Metalex Manufacturing Inc.

Packing List# 39513 **Rel#** 1 **PAGE** 1
Metalex Job# 2006-5688

P.O. Item No.	Qty Ordered	Qty Shipped	Qty Back Ordered	Description
004	15	1	8	LCLS UNDULATOR MAIN ASSY ANL PART/REVISION NUMBER: L143-112000-05 SLAC PART NUMBER: SA-381-001-35 ASSEMBLY SERIAL NUMBER: 5A10359-16 STRONGBACK SERIAL NUMBER: 5A0699-16 THE FOLLOWING BOM ITEMS ARE LOOSE PARTS PACKAGED WITHIN THIS CRATE, BUT NOT ASSEMBLED TO THE MAIN STRUCTURE: ITEM# 12 L143-110109 BRACKET 1 QTY-10 ITEM# 13 L143-110110 BRACKET 2 QTY-10 ITEM# 14 L143-110111 SCREW QTY-40 ITEM# 17 91292A122 SHCS M4X0.7X25MM LG QTY-20 ITEM# 18 91292A135 SHCS M6X1.0X16MM LG QTY-20 ITEM# 24 L143-110703 PEAK FIELD SHIM QTY-20 PLEASE ENSURE THESE ITEMS ARE ACCOUNTED FOR WHEN MAIN STRUCTURE IS REMOVED FROM CRATE. -CERTIFICATE OF CONFORMANCE, INSPECTION DATA, AND CERTIFICATIONS ENCLOSED. ANL SOURCE: SIGNATURE: Glen Lawrence DATE: 12/20/06 PRINT: Glen Lawrence STAMP:

CERTIFICATE OF CONFORMANCE

PROJECT: STRONGBACK DEVIATION
PROJECT: ARGONNE
DRAWN BY: T.J.RAUCH
DATE: 17AUG05
CHECKED BY: T.J.RAUCH
DATE: 17AUG05
SCALE: FULL
INCH X METRIC
SHEET 1 OF 2 3801
AutoCAD Release 14
DRAWING NO
SDR 3801-004
REV D

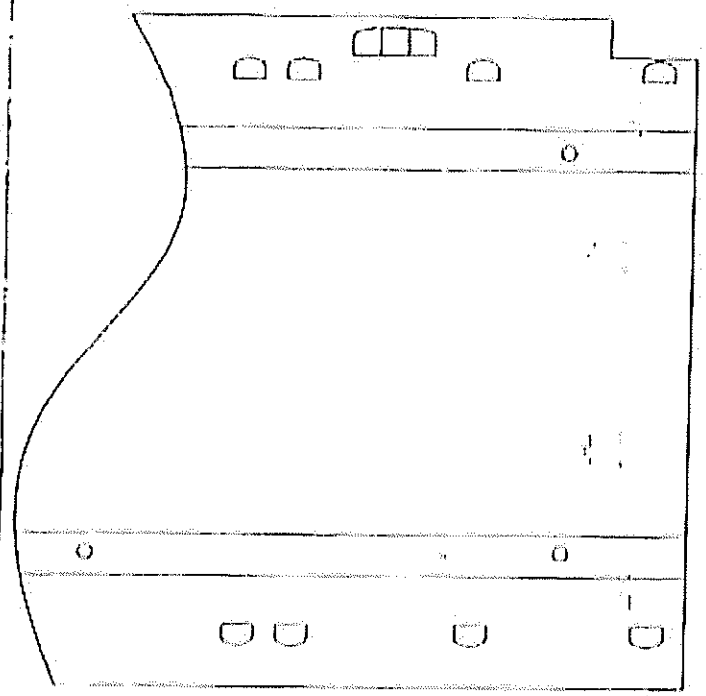
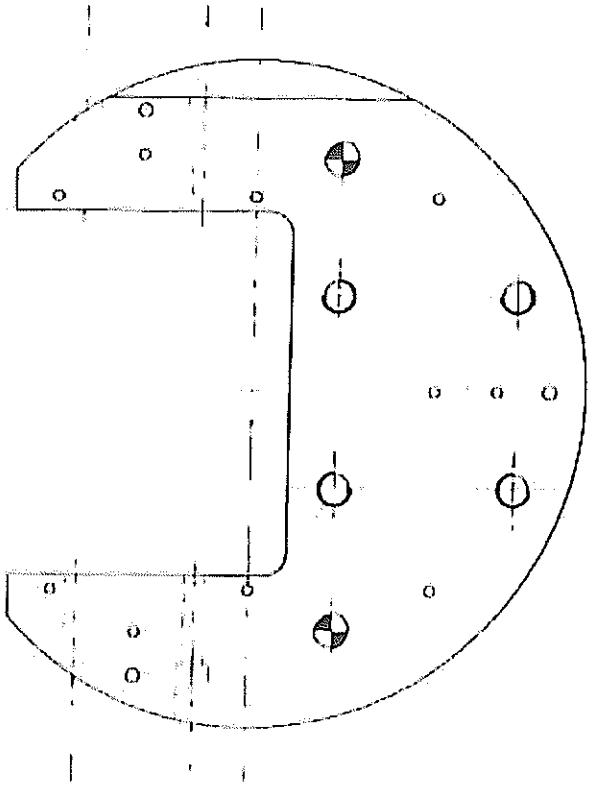
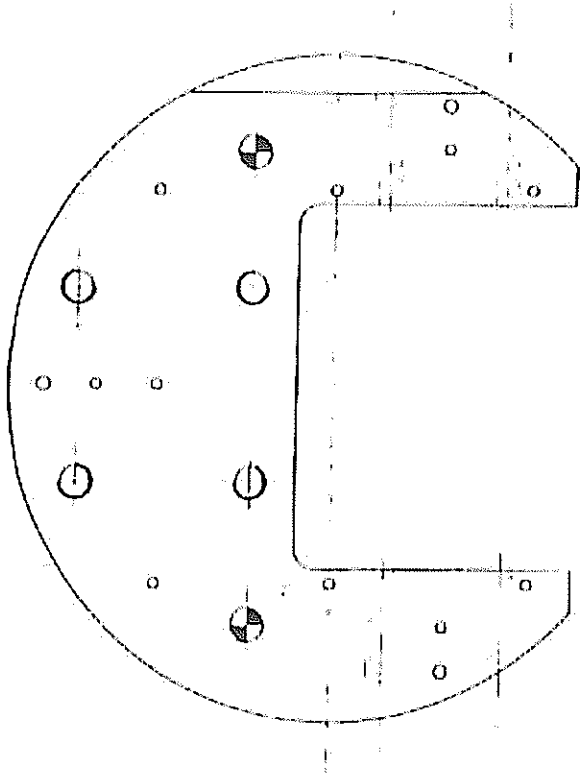
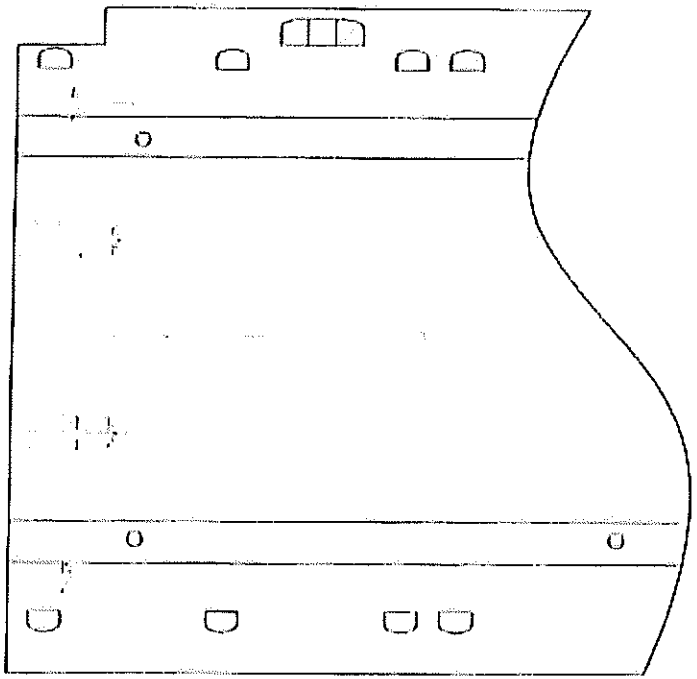
7. Qty.	8. Describe Nonconforming Condition	9. Identify Requirement	10. Cause & Corrective Action
	1) Along with this form, Metalex has attached a sketch named SDR 3801-004, pages 1 and 2. This sketch outlines some additional "for manufacturing process only" holes that Metalex is requesting permission to add to the Strongback details. On each end of each part, (4) 5/8-11 tapped holes and (2) .6250" diameter dowel pin holes are requested to be added for internal use at Metalex.	Metalex requests direction from ANL on this item

17. ANL Disposition and Remarks: The requested modifications for internal Metalex use are allowed.

STRINGBACK PROCESS	ARGONNE
R SCHUERMANN 03NOV05	
R SCHUERMANN 03NOV05	FULL / INCH / X / METRIC
1 OF 2 / 3801	DRAWING No MXPL143-110700-03 / REV. D
AutoCAD Release 14

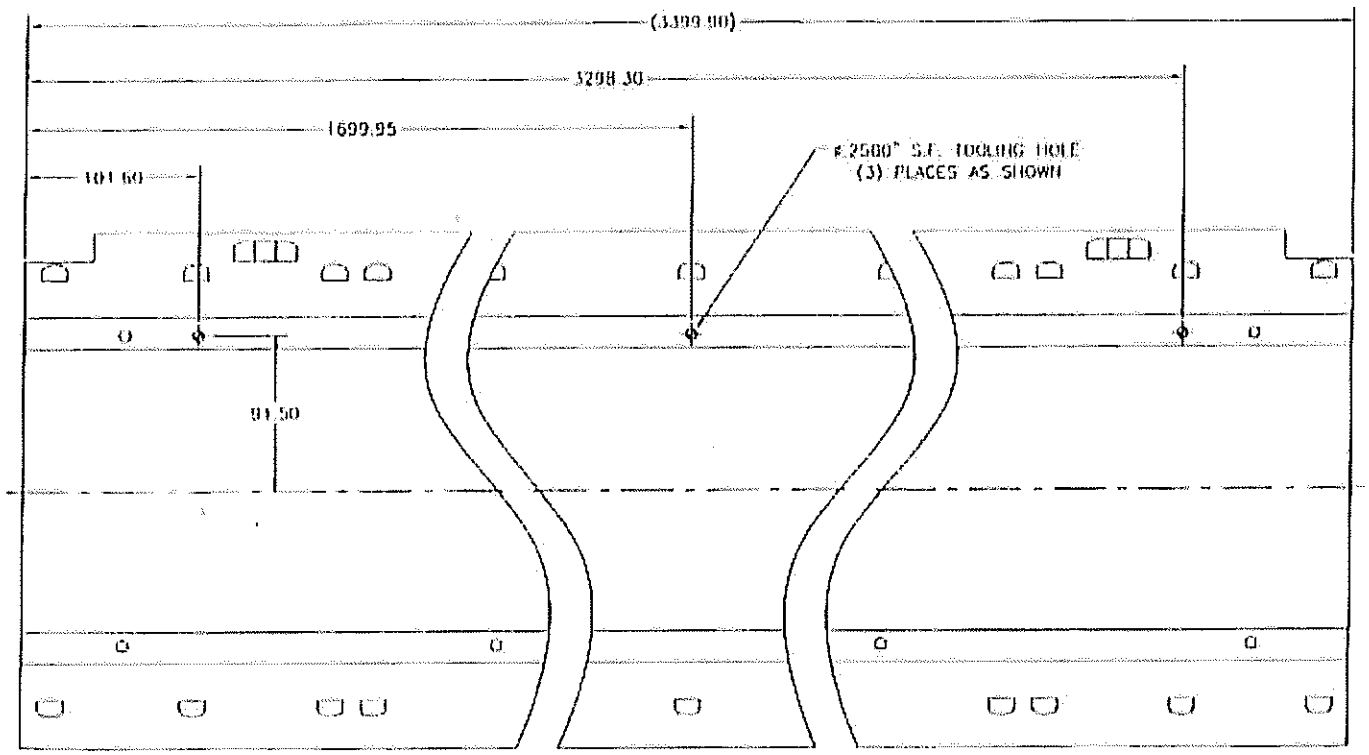
7. Qty.	8. Describe Nonconforming Condition	9. Identity Requirement	10. Cause & Corrective Action
	1) Along with this form, Metalex has attached a sketch named MXPL143-110700-03. This sketch outlines some additional "for manufacturing process only" holes that Metalex is requesting permission to add to the production Stongback details. These three (3) .2500" diameter tooling holes located as shown will allow ease of manufacturing and inspection of the critical overall length of this detail.	Metalex requests direction and approval from ANL on this item.

These three (3) .2500" diameter tooling holes located as shown will allow ease of manufacturing and inspection at the critical overall length of this detail
